TO: Steve Lewis, City Manager
FROM: Terry Floyd, Development Coordinator
DATE: February 13, 2018
SUBJECT: Change Order #5 – Norman Public Library Central

Change Order

Re: **NORMAN CENTRAL LIBRARY CO #005 EXPLANATIONS**

Question C901 Date Required: 9/27/2017
Reference Sheet C901

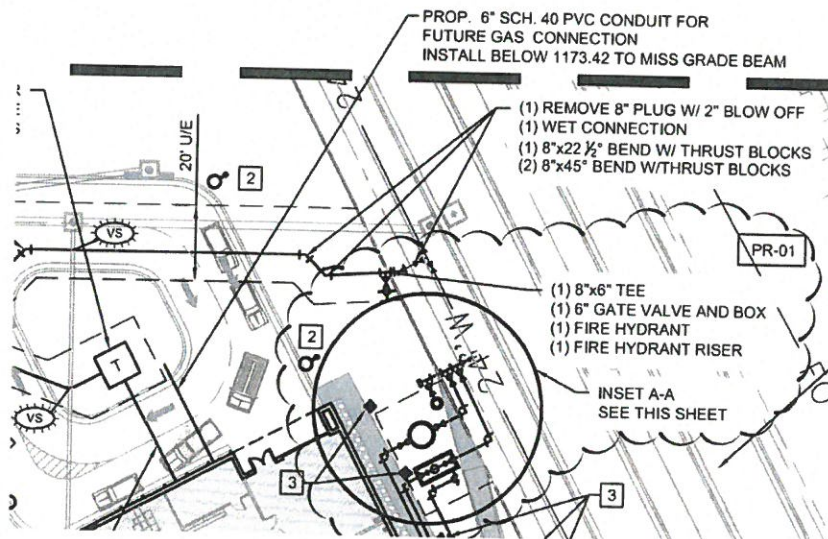
Sheet C901 calls for a 6" sleeve to be installed from the "drop-off" island to the electrical room. The sleeve will need to have a 90 degree fitting added to bring it up into the room from below the grade beam. There is concern that the gas line installer may not be able to install the gas line through the sleeve if it has a 90 degree bend in it.

- 1) Please confirm that gas line installer can install the future gas line through the sleeve with a 90 degree bend.
- 2) Please confirm the electrical room is the proper place for the future gas line to enter.

There is no gas installer at this time to discuss this with. Design team has not been informed by gas company as to what size future might be, or might never be, installed through sleeve. My recommendation is to install a sweeping 90 and work with gas company in the future if gas is ever used on site. The location of the stub up was coordinated with the design team during design and the proposed location was the decision that was agreed upon.

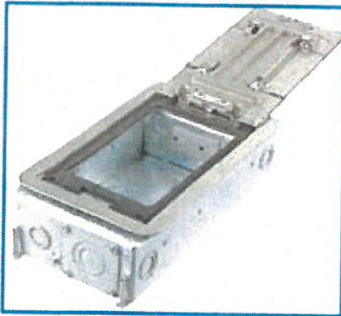
The floor boxes approved through RFI #67 and Submittal #143 need to be redefined again because the product has been discontinued.

Please review attached sheets from the current Hubbel catalog that show their current options for FB's compatible with hard floors and advise.

*****An expedited response is requested so the (6) recessed boxes at Rooms 136 and 123 can be released and roughed in prior to the SOG pour scheduled for 10/27/17. Blocking these out is not recommended at Room 136 where the finish is scheduled to be exposed concrete.*****

There is not an exception to this product.

Options are not selected in this document:

+it appears for FB-1 and FB-2, the 4-gang option is acceptable to accommodate the devices indicated. Please verify.

+Cast iron or Corrosion Resistant construction is preferred in concrete topping. Coordinate exact product with available depth of floor pour.

+Provide flush lid where floor is finished concrete, provide surface type lid for wood floor install

+I like rectangular lid, but please verify lid shape and color with MSR.
